HISTORIC AND DESIGN REVIEW COMMISSION

February 07, 2018

HDRC CASE NO: 2018-031
ADDRESS: 803 BURLESON ST
LEGAL DESCRIPTION: NCB 1301 BLK 2 LOT 14
ZONING: R-5, H
CITY COUNCIL DIST.: 2
DISTRICT: Dignowity Hill Historic District
APPLICANT: Roberto Velazquez
OWNER: Roberto Velazquez
TYPE OF WORK: Front Yard Fence
APPLICATION RECEIVED: January 3, 2018
60-DAY REVIEW: March 4, 2018
REQUEST:

The applicant is requesting a Certificate of Appropriateness for approval to install a four (4) foot tall front yard fence.

- Proposed Location for new fence

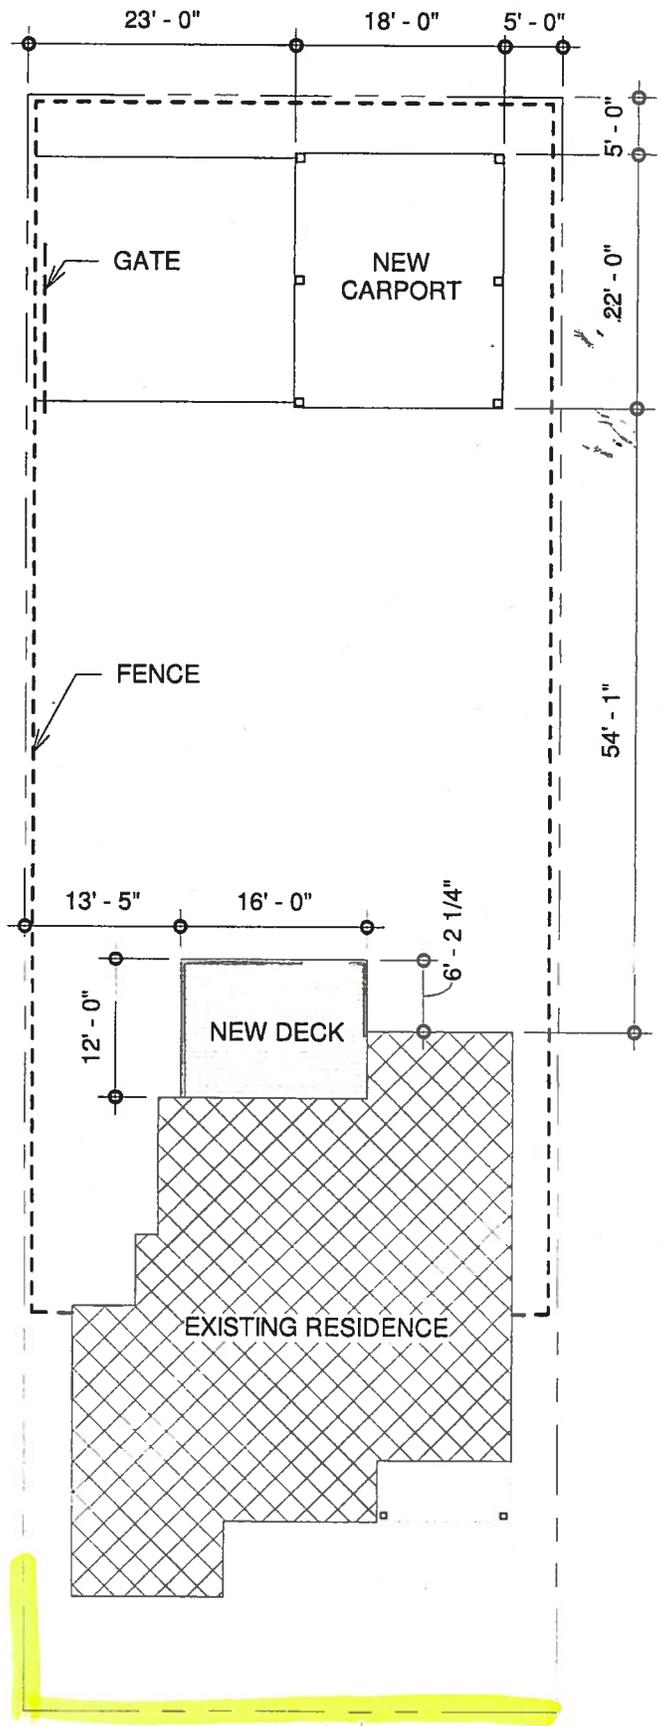
- b. FENCING – The applicant has proposed to construct a front yard, cattle panel fence to feature four (4) feet in height. This block of Burleson features seventeen historic structures, nine of which feature front yard fencing. On the north side of the block, two properties feature front yard fencing. While many houses on this block feature front yard fencing, many fences in existence are chain link.

- c. FENCING – The Guidelines for Site Elements 2.B.ii. notes that fencing should not be installed in a location where one did not historically exist. Additionally, front yard fences should not be introduced within districts that

have not historically had them. While this block of Burleson features many lots with non-historic examples of fencing, staff finds that the installation of fencing is appropriate in the Dignowity Hill Historic District. Additionally, the design of the proposed fencing is appropriate for the Craftsman style of the historic structure.

Staff recommends approval as submitted based on findings b and c.
